**County of San Diego
Planning & Development Services
BUILDING DIVISION**

ACCESSIBILITY CORRECTION LIST Multifamily Housing	8A
Elevators and Platform Lifts

**FIGURE 11A-7C
 HOISTWAY AND ELEVATOR ENTRANCES**

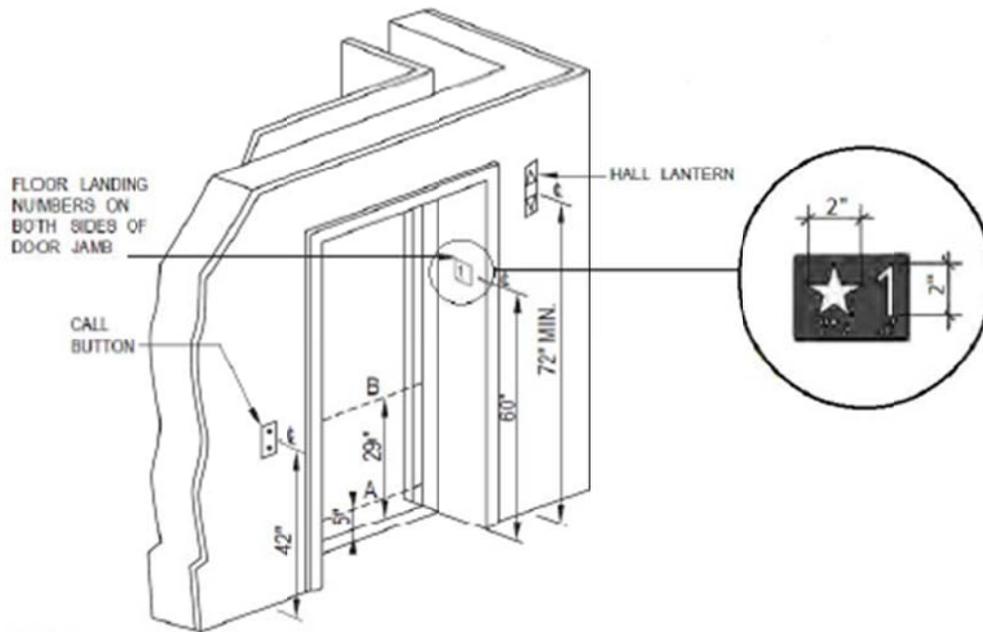
- Do not require contact for activation
 - Remain effective for not fewer than 20 secondsCBC 1124A.9
- Detail doorjamb marking complying with the following at each lobby elevator hoistway entrance per CBC Figure 11A-7C:

- Indicating respective floor number
 - Located on both sides of door and visible from within elevator car
 - Located per the following:
 - o Minimum 48 inches from finish floor or ground surface to baseline of lowest line of Braille

- o Maximum 60 inches from finish floor or ground surface to baseline of highest line of raised characters
 - Floor numbers designated by raised characters minimum 2-inches high on contrasting background and otherwise complying with item 25

- Grade level designated by raised five-pointed star with 2-inch (absolute) outside diameter placed to left of floor-designation number on contrasting background and otherwise complying with item 25

- Corresponding Braille per item 26 beneath raised characters

(a) ELEVATOR CONTROL PANEL DETAIL
FIGURE 11A-7B
ELEVATOR CONTROL PANEL

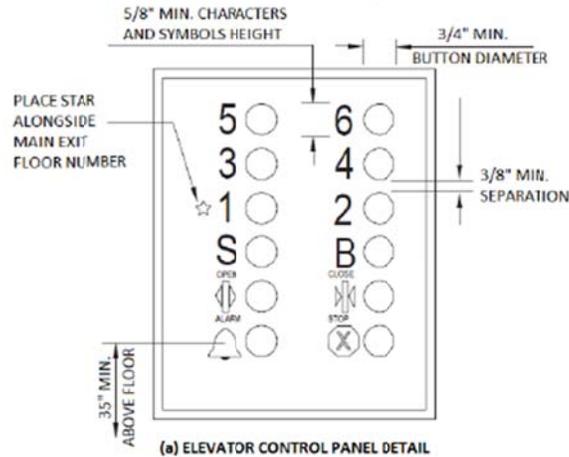
10. Detail car control and emergency buttons complying with following per CBC Figure 11A-7B(a):

- Minimum 3/4-inch-diameter control buttons raised 1/8 inch +/- 1/32 inch above surrounding surface
- Illuminated control buttons with square shoulders and activated by detectable mechanical motion
- Minimum 3/8-inch clear space or separation between rows of control buttons
- Raised characters per the following:
 - o Located immediately to left of control buttons
 - o White on black background
 - o Otherwise complying with item 25
- Raised symbols per the following:
 - o Provided for controls and emergency equipment including – but not limited to – “door open,” “door close,” “alarm bell,” “emergency stop,” and “telephone”
 - o Five-pointed star at call button for main entry floor
 - o Located immediately to left of control buttons
 - o White on black background
 - o Otherwise complying with item 25

- ❑ Corresponding Braille per item 26 beneath raised characters and symbols
